ISSUE: Permit to Demolish/Capsulate (partial), Certificate of Appropriateness for addition and alterations,

APPLICANT: John and Susan Nelson

LOCATION: Old and Historic Alexandria District
318 South Fairfax Street

STAFF RECOMMENDATION

1 FIRST FLOOR PLAN - PROPOSED

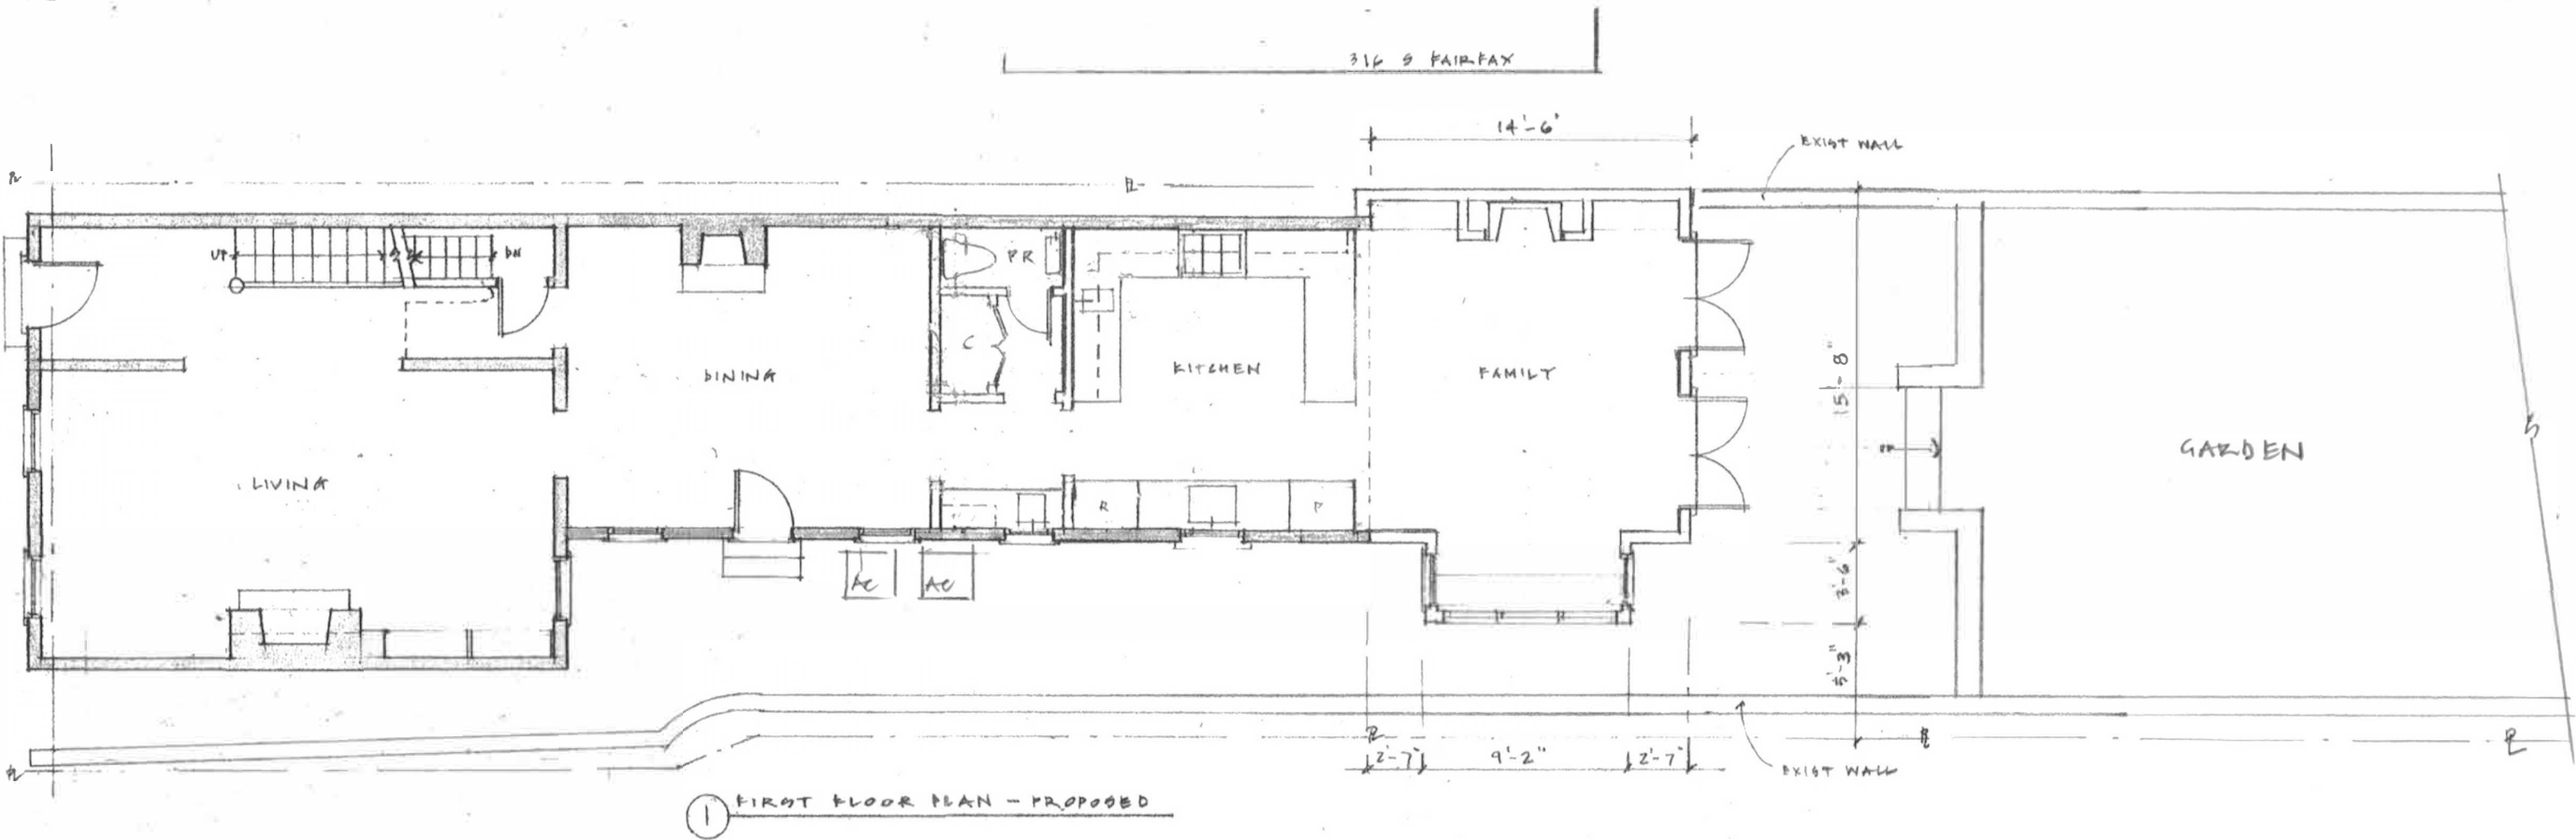
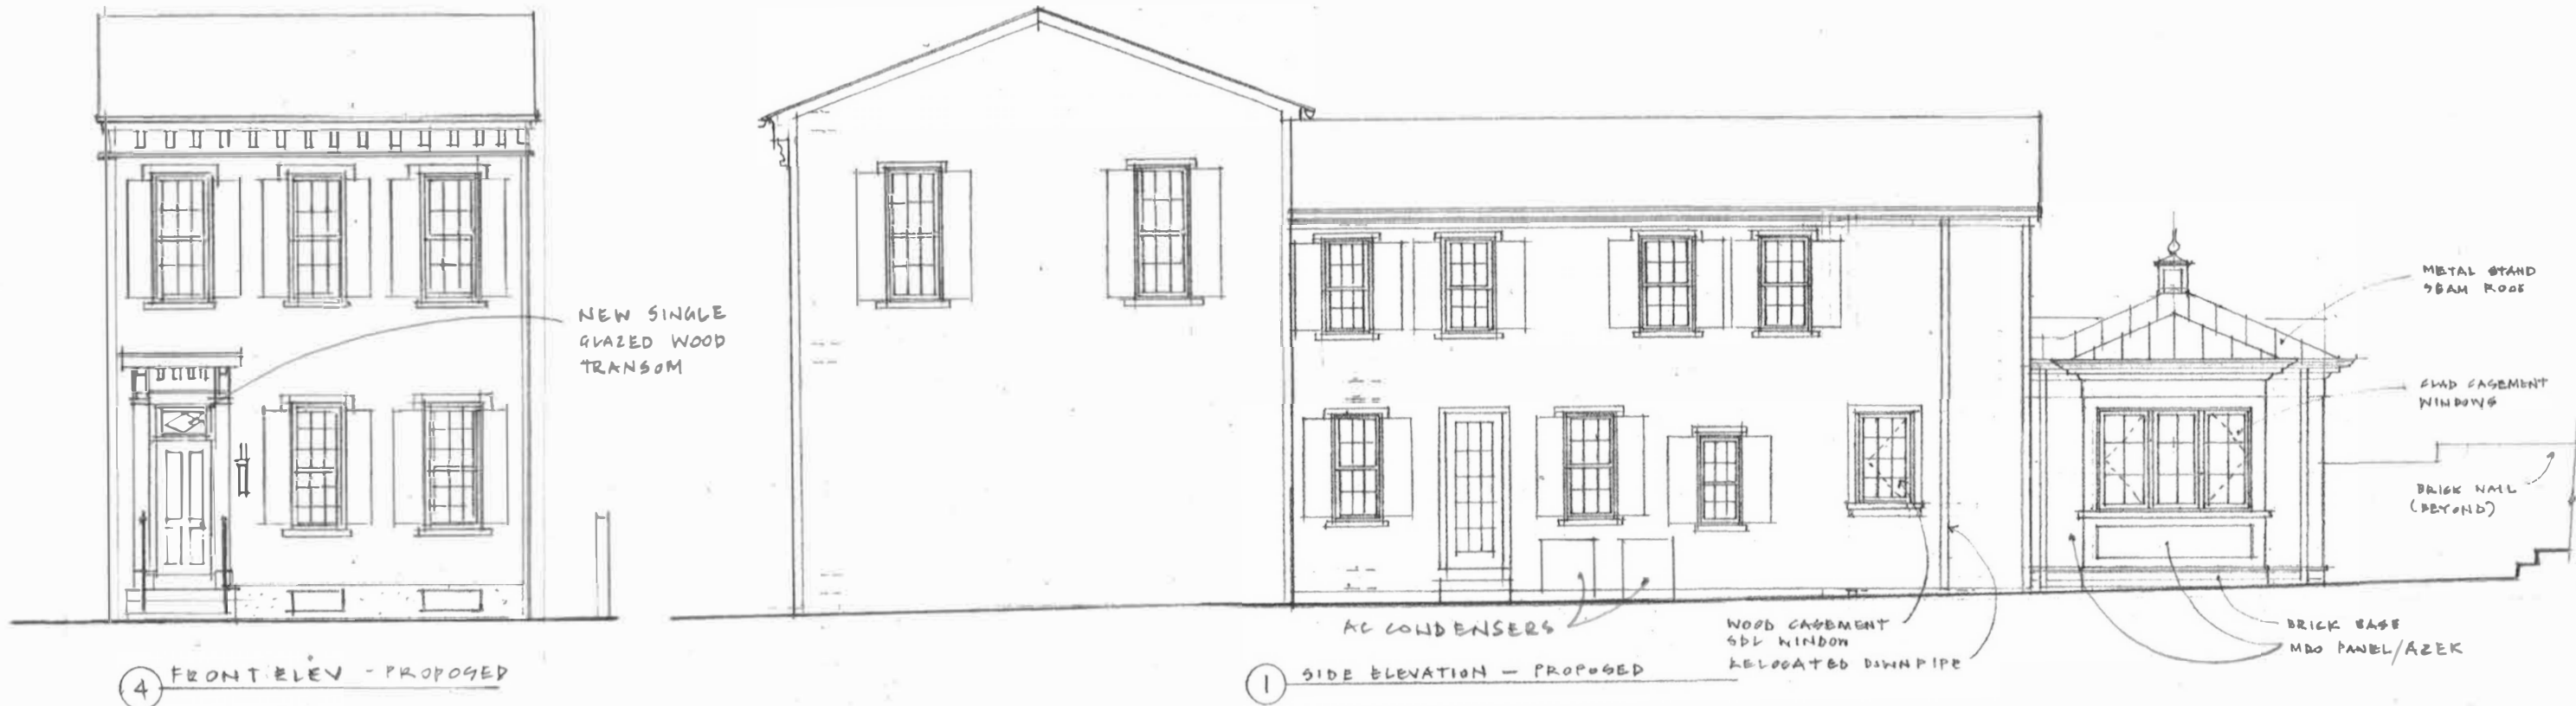
C-1 Proposed relocated AC unit are 5' from the side property line and comply with zoning.

I live next door to 318 South Fairfax Street and would like to comment on their application for an addition. The preliminary plans that the homeowner showed me have an air conditioning unit on the one-story roof at our property line immediately adjacent to my house. When I mentioned that having the air conditioner in that location was not desirable for us, she kindly said that she would immediately contact the architect to have the plans redrawn. I believe the air conditioner should either be on the opposite side of the roof or on the ground. I am not able to view the meeting live and won't be able to see which set of drawings the homeowners present to you, so I am submitting these comments before the BAR meeting. The rest of their addition plans look fine to me.

Mr. and Mrs. Nelson showed me their revised plans with the change in the location of the air conditioner unit, and that is completely fine with me. They asked me to write and let you know.
